Technical Service Bulletin: tsb100219

Released Date: 21-Jul-2003

Hand Hole Cover o-ring Change

Hand Hole Cover o-ring Change

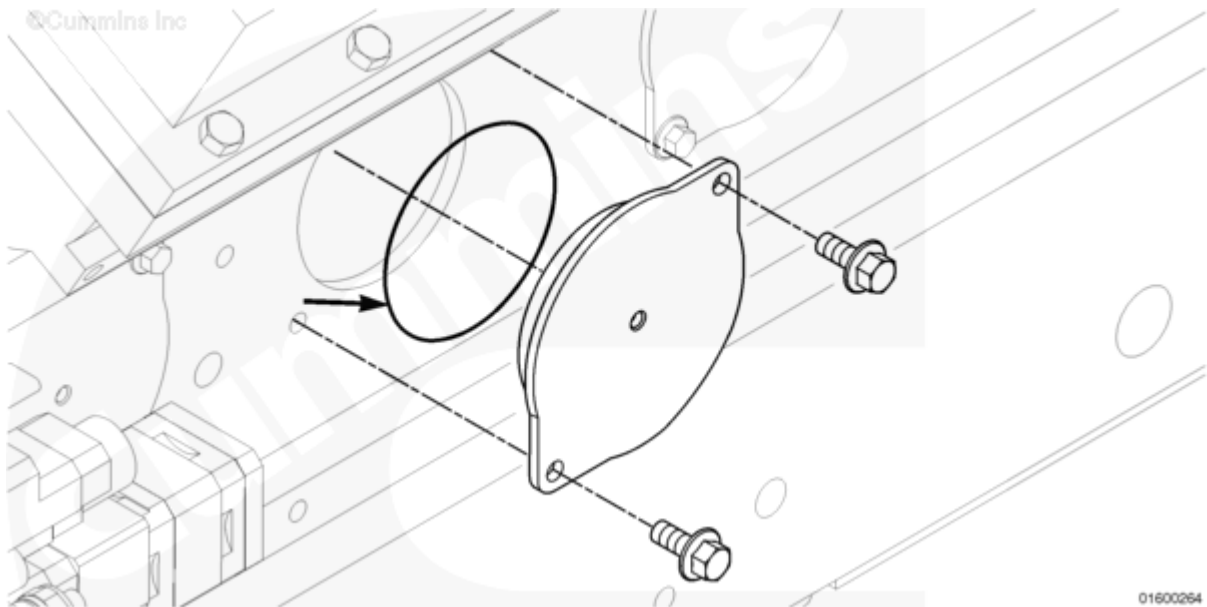
This Technical Service Bulletin provides information regarding the product improvement of the o-ring for the hand hole cover on QSK45 and QSK60 engines. This improvement consists of an o-ring material change.

The purpose of this change is to improve o-ring durability.

The original o-ring, Part Number 3089370, was made from a nitrile based material. The new o-ring, Part Number 4100660, is made from a viton based material. Engine serial number first for this change 33153345, build date January 21, 2003
